**PCN# 20131216002
Qualification of Carrier Tape for Select
UQFN Package Devices
Information Only**

Date: 12/19/2013

PCN Number:	20131216002		PCN Date:	12/19/2013																			
Title:	Qualification of Carrier Tape for Select UQFN Package Devices																						
Customer Contact:	PCN Manager	Phone:	+1(214) 480-6037																				
Dept:	Quality Services																						
Change Type:																							
<input type="checkbox"/>	Assembly Site	<input type="checkbox"/>	Assembly Process	<input type="checkbox"/>	Assembly Materials																		
<input type="checkbox"/>	Design	<input type="checkbox"/>	Electrical Specification	<input type="checkbox"/>	Mechanical Specification																		
<input type="checkbox"/>	Test Site	<input checked="" type="checkbox"/>	Packing/Shipping/Labeling	<input type="checkbox"/>	Test Process																		
<input type="checkbox"/>	Wafer Bump Site	<input type="checkbox"/>	Wafer Bump Material	<input type="checkbox"/>	Wafer Bump Process																		
<input type="checkbox"/>	Wafer Fab Site	<input type="checkbox"/>	Wafer Fab Materials	<input type="checkbox"/>	Wafer Fab Process																		
<input type="checkbox"/>		<inp

CHANGE FROM 3M081981 TO 3M117081 Carrier Tape

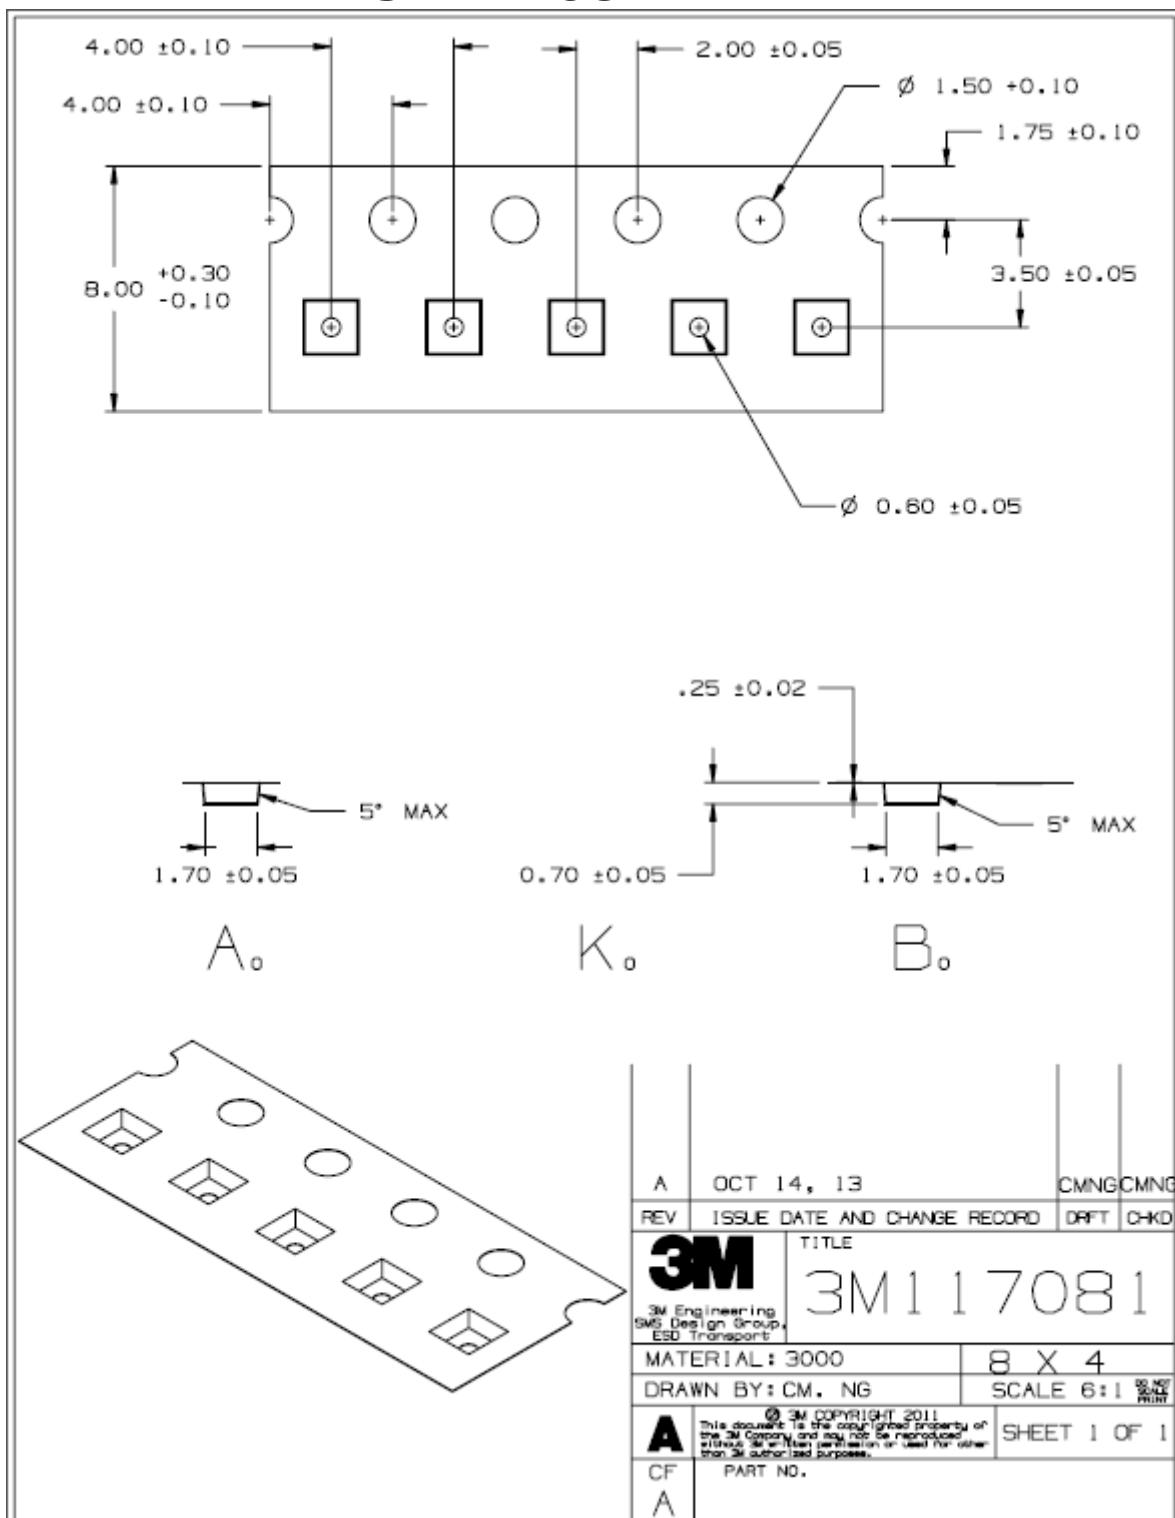
From: **3M081981**

To: **3M117081**
